# State, Federal and Tribal Fishery Agencies Joint Technical Staff

## ***Agencies and tribes review comments – Bonneville Power Administration Summer Spill Analysis***

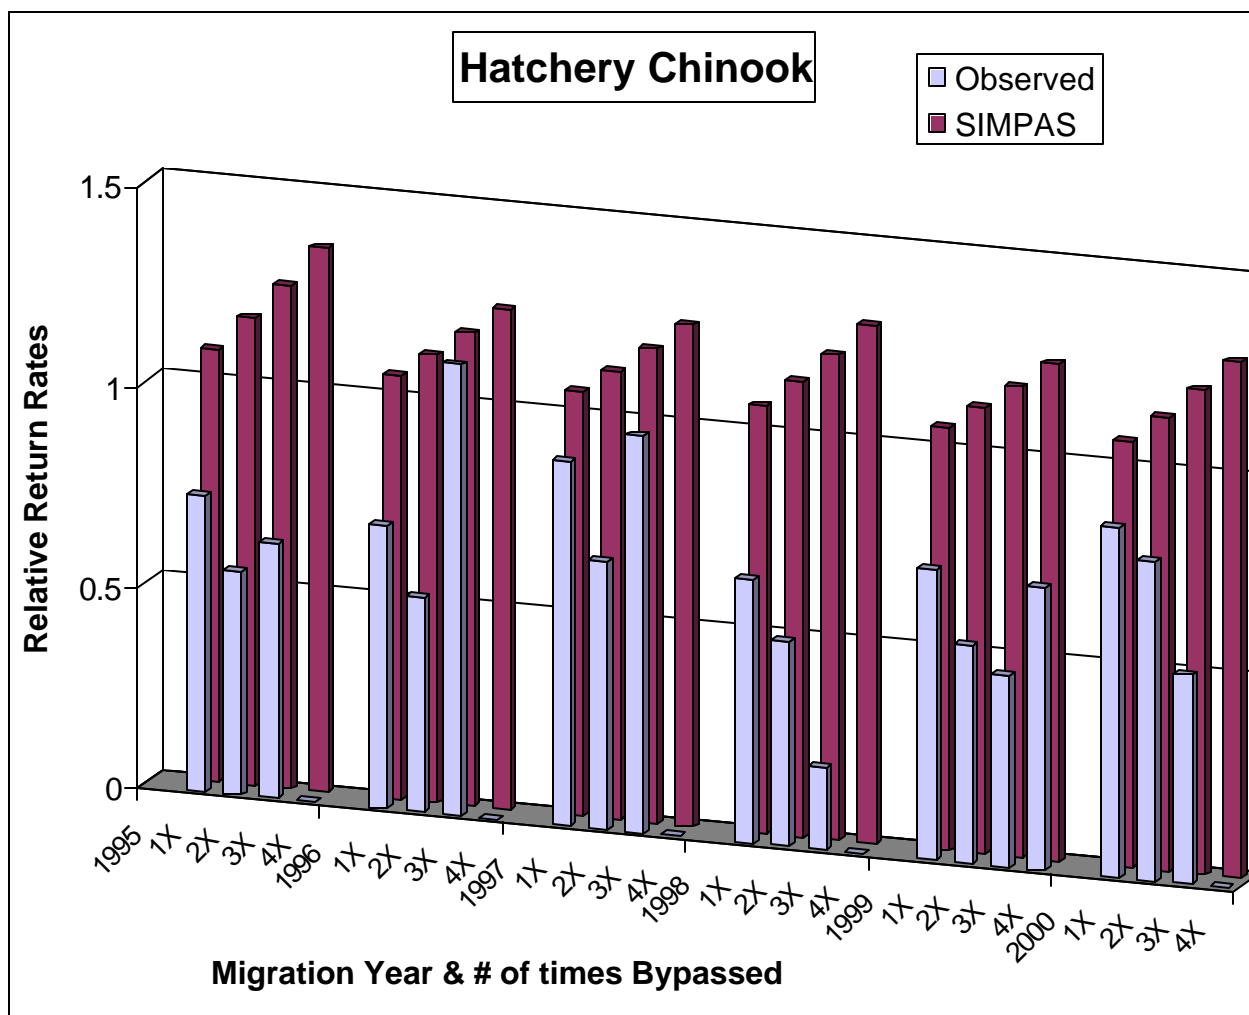
For example, to illustrate limitations of SIMPAS discussed in the previous paragraphs, we compared empirical data available for spring chinook against SIMPAS predicted results for spring chinook. The following comparison clearly shows that using SIMPAS to predict adult impacts from reduced spill will probably seriously underestimate the true impacts of reducing spill (Figure 1).

This figure shows the observed adult return rate of PIT-tagged hatchery spring/summer chinook smolts relative to the NOAA estimates for the non-detected smolt group (light blue bars), and the SIMPAS prediction of these relative adult return rates (dark red bars). Hatchery spring/summer chinook salmon smolts were selected for this evaluation of SIMPAS's adult return predictive ability because they are the species, run, and rearing group with the best PIT tag data set, and there is currently no comparable data set for Snake River fall chinook. From these empirical results, two important points concerning using SIMPAS to predict impacts to fall chinook from summer spill reductions are clear. SIMPAS does not accurately predict adult return rates. In this example, SIMPAS consistently over estimated the adult return rates (is positively biased) relative to the observed values for the various in-river groups (Figure 1).

Figure 1. Relationship between sport-reward exploitation and mean gage height below Bonneville Dam during the fishery season, 1995-2003.

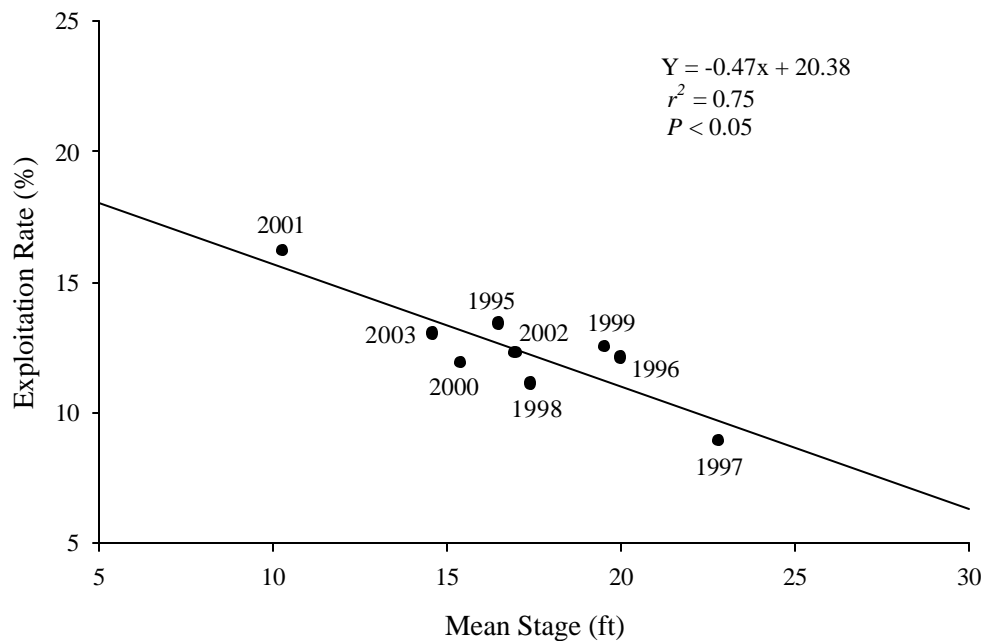
The increase in catch and exploitation in 2001 is at least partially explained by the environmental conditions that lead to the “heavy-up” (i.e., low river flow). Information collected since 1995 indicates that exploitation of northern pikeminnow (>250 mm) by the sport-reward fishery is highly correlated with river flow (mean gage height below Bonneville Dam) during the fishery (Figure 1). The analysis is limited to fish >250 mm to ensure consistency among years.

Although variation should be considered when using this information to make specific recommendations, it is apparent that differences in flow alone, and not increases in rewards, could account for exploitation in 2001 being approximately 3% higher than exploitation in 2000, 2002, and 2003 (observed differences in point estimates ranged from 3.2% to 4.3%). Exploitation rate in 2001 was slightly higher than would be predicted from the relationship (Figure 1); however, this is also true for 1995, 1996, and 1999.

Figure 2. Relationship between catch of northern pikeminnow (>250 mm) and exploitation rate, 1995-2003.

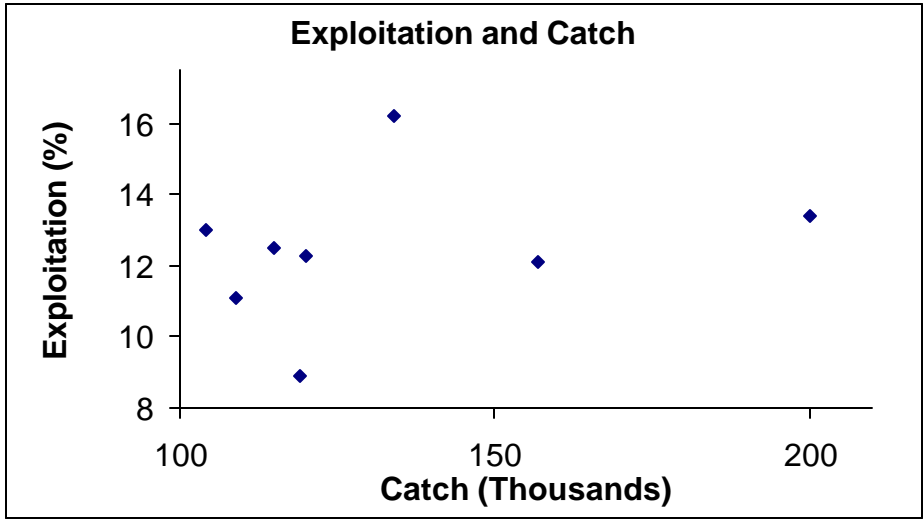
out of the project area), but exploitation estimates do not. We have found that catch is not a reliable predictor of exploitation rate (Figure 2;  $P > 0.05$ ).

Figure 3. Relationship between exploitation rate on northern pikeminnow before and after July 10, 1995-2003. Although not included here, confidence limits around each point are relatively wide, and similar in proportion to those in Table 1.

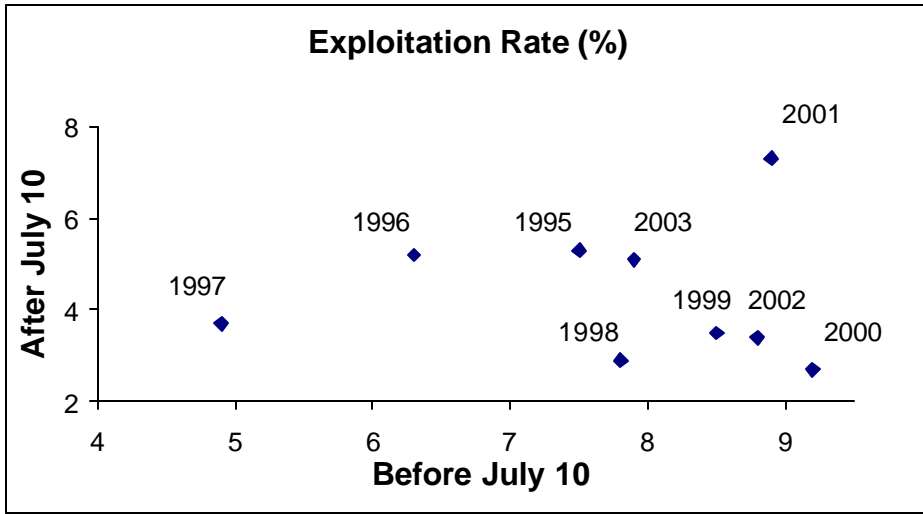
similar to that in many other years. Exploitation after July 10 in 2001 appears much greater than would be expected based on 1998-2000 and 2002 data; however, the pattern of exploitation in 2001 is similar to that observed from 1995-97 and in 2003. Differences in flow among years with seasonal similarities in exploitation patterns (Figures 1 and 3) further exemplify the difficulty in attributing changes in exploitation to a particular cause.

Figure 4. Relationship between catch of northern pikeminnow before and after July 10, 1995-2003.

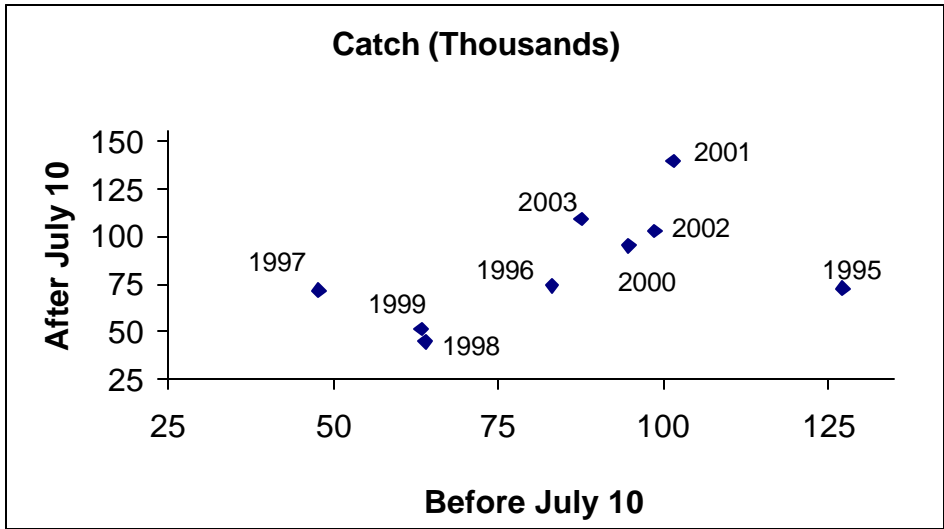
We also found no significant relationship between catch of northern pikeminnow before and after July 10 (Figure 4;  $P > 0.05$ ). Examination of the information indicates that the seasonal change in 2001 was similar to that in most other years. The relationship between catch before and after July 10 in 2001 was similar to that from all years except 1995 and 1997.

Travel time distribution for sub-yearling chinook released July 4 from McNary Dam to Bonneville Dam in 1999 to 2002

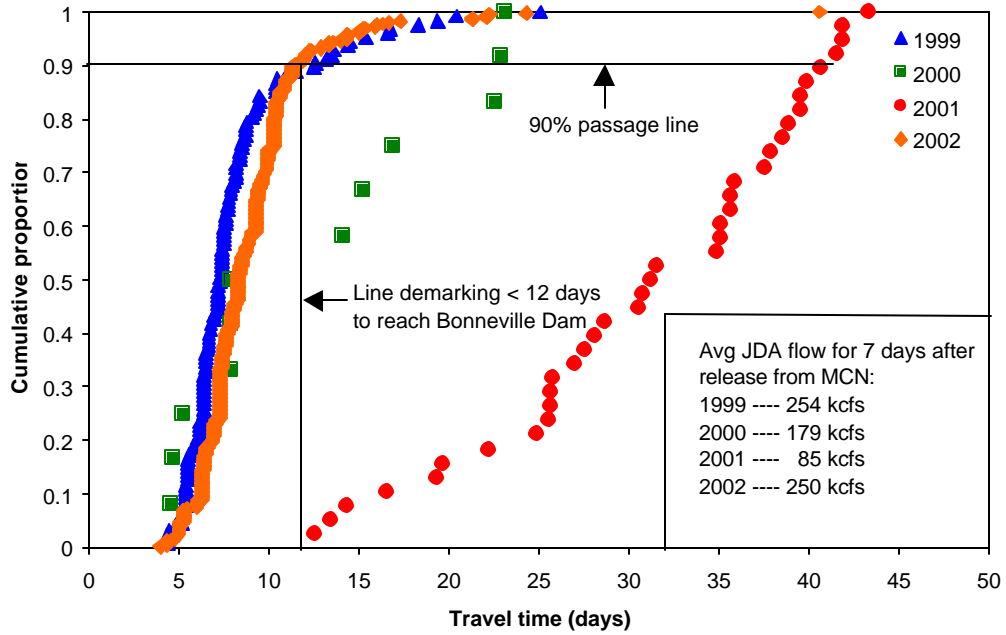
- Travel time estimates were generated for two groups of fish released at McNary dam. The first group was released in early July (July 4) and the second group was released in late July (July 18). The early releases were compared to each other over four years with varying flows. The late releases were compared to each other over the same years of varying flows.
- The early July groups of sub-yearling chinook had shorter travel times in the higher flow years of 1999 and 2002. These shorter travel times resulted in an earlier passage distribution of 90% of the smolts at Bonneville Dam than in the years of lower flows.

Travel time distribution for subyearling chinook released July 18  
from McNary Dam to Bonneville Dam in 1999 to 2002

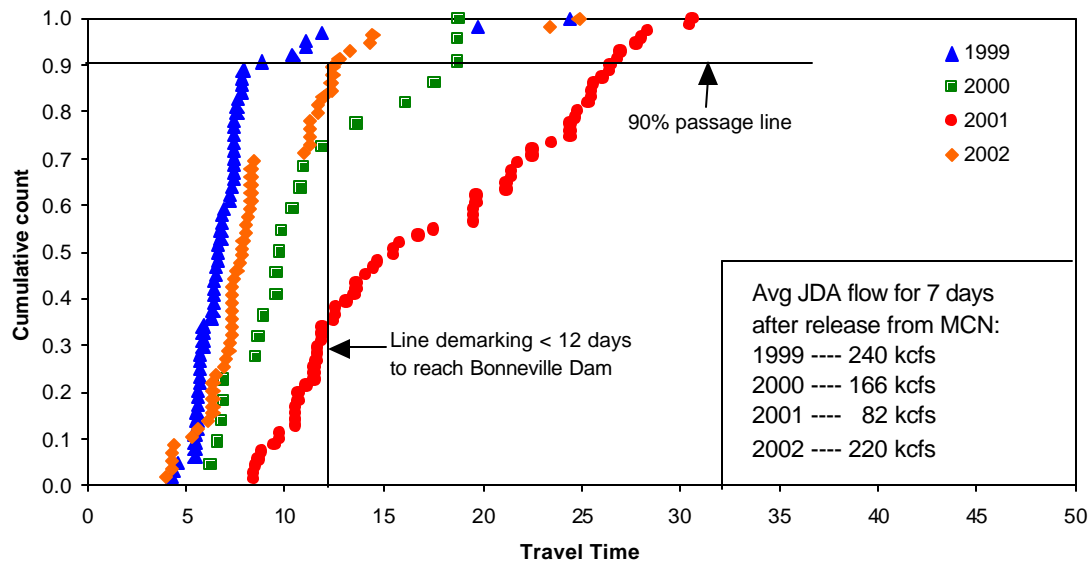
- Similar to the results of the early migrating groups, the late migrating release groups of sub-yearling fall chinook had shorter travel times in the higher flow years of 1999 and 2002 and therefore, an earlier passage distribution of 90% of the smolts at Bonneville Dam than in the years of lower flows.

Note: Horizontal jump in cumulative at 0.7 in 2002 is due to an apparent equipment problem at Bonneville Dam Powerhouse 2 detectors during period of July 27- 28. The result is a shifting to the right of the cumulative curve above 0.7 in a magnitude more than actually occurred that year.

**Figure 1. Relative survival of Snake River spring/summer chinook stocks compared to downriver stocks, smolt years 1977-1992 (Source: Deriso in press).**

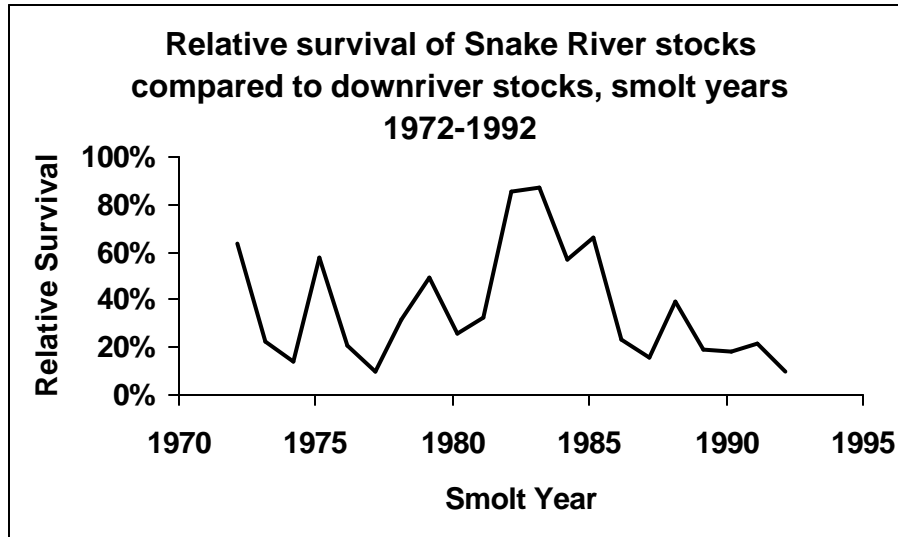
stocks which originate above fewer dams (Deriso et al. 1996; Schaller et al. 1999, 2000; Deriso in press). Prior to dam construction, Snake River stock survival equaled that of the downriver stocks. The relative survival of Snake River stocks compared to downriver stocks for smolt years 1972-1992 (Figure 1) has ranged from 6% in smolt year 1992 (a low flow year) to 84% in 1983 (a

high flow year). Although a number of hydrosystem modifications were implemented during this period, there was no empirical suggestion of an increasing trend in relative survival over time.

**Figure 2. Relative survival of Snake River stocks compared to downriver stocks versus Snake River flow during spring migration season, smolt years 1977-1992.**

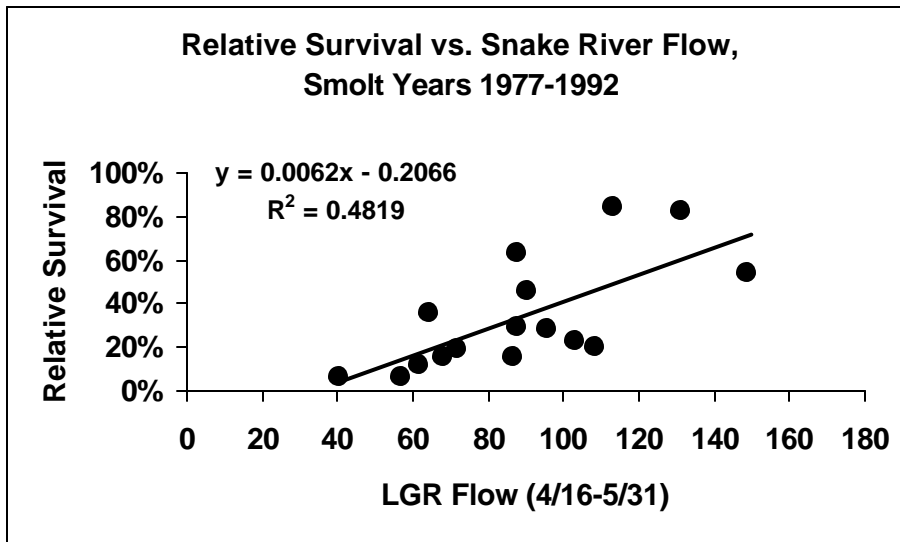
Projected Snake River flows in the 2001 spring migration might be as low as 40 kcfs. The relationship indicates that at a projected Snake River flow of 40 kcfs Snake River stocks will survive at a much lower rate than downriver stocks (Figure 2). In addition, the relationship indicates that for a projected flow of 60 kcfs Snake River stocks will also survive at a considerably lower rate compared to the downriver stocks' rates.

**Figure 3. Relative survival of Snake River stocks compared to downriver stocks versus average spill at Snake River dams during spring migration season, smolt years 1977-1992.**

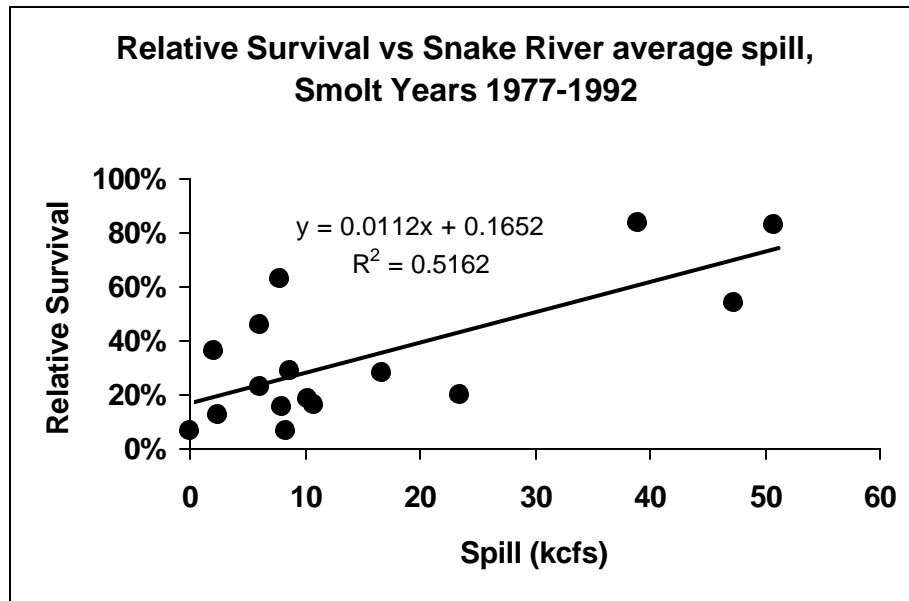
Historic stock performance of Snake River stocks also correlated significantly with spill at Snake River dams (Figure 3). Because flow and spill are also positively correlated, and both are beneficial, this is expected. Spring 2001 spill would be zero at collector projects under the BIOP operations, and some proposals have been made for full curtailment of spill. The relationship would indicate that for zero Snake River spill the Snake River stocks' survival rates would be much lower than the downriver stocks'.

The historical record suggests poor survival of Snake River stocks for mainstem conditions projected in 2001. Based on historic information, Snake River spring/summer chinook return rates may be only 5% - 20% those of downriver stocks (which will also be negatively affected by poor mainstem conditions). Yet the NPPC issue paper (Table 3) implies Snake River stocks will survive to returning adult at least 19% better than stocks migrating through the lower Columbia River hydrosystem from the 2001 juvenile migration. This does not seem biologically realistic, based on historic patterns.
